## Tender FAQs from Question n.1 to Question n.82

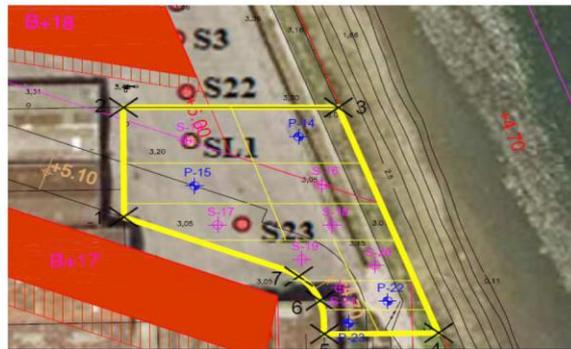
- 51.1 Page 26, Figure 177. The name of the sampling points is not clear. Could you provide a better resolution image?
- 51.2 Piezometers on Figure 166 (page 23) and Figure 177 (page 26). We would like to know de depth of each piezometer and a geological description.
- 51.3 Page 27. Results of soil chemical analysis. We would like to know the depth of each sample and the location of the sampling points.
- 51.4 Page 28. Results of groundwater chemical analysis. We would like to know the location of the sampling points.

51.1 Please [click here](#) to download a high-resolution version of Figure 177
